FINAL PLAT OF CASTLE ROCK - PHASE 2

STANDARD FINAL PLAT REVIEW

Subdivision Name: Final Plat of the Castle Rock Addition, Phase 2

Project Number: 22-00030-S-SUBD

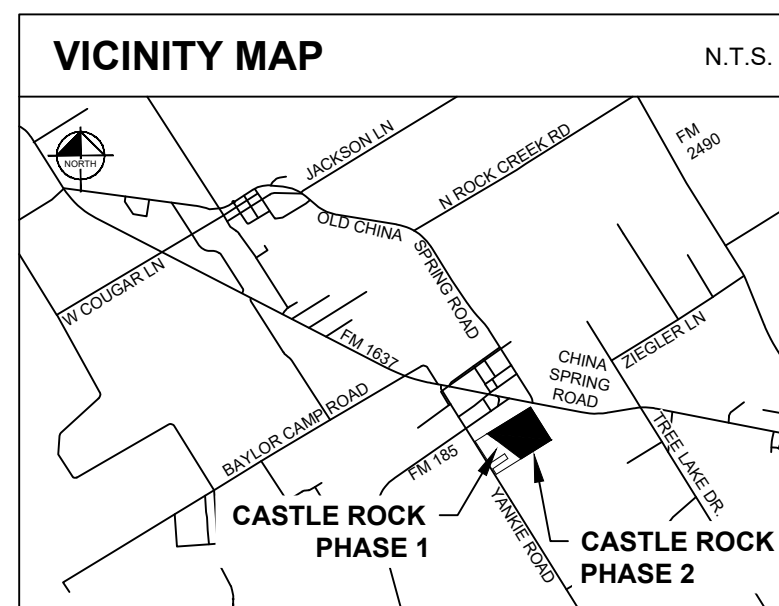
- P1. Please add N & E to POB call-out. (Completed)

City condition satisfied.
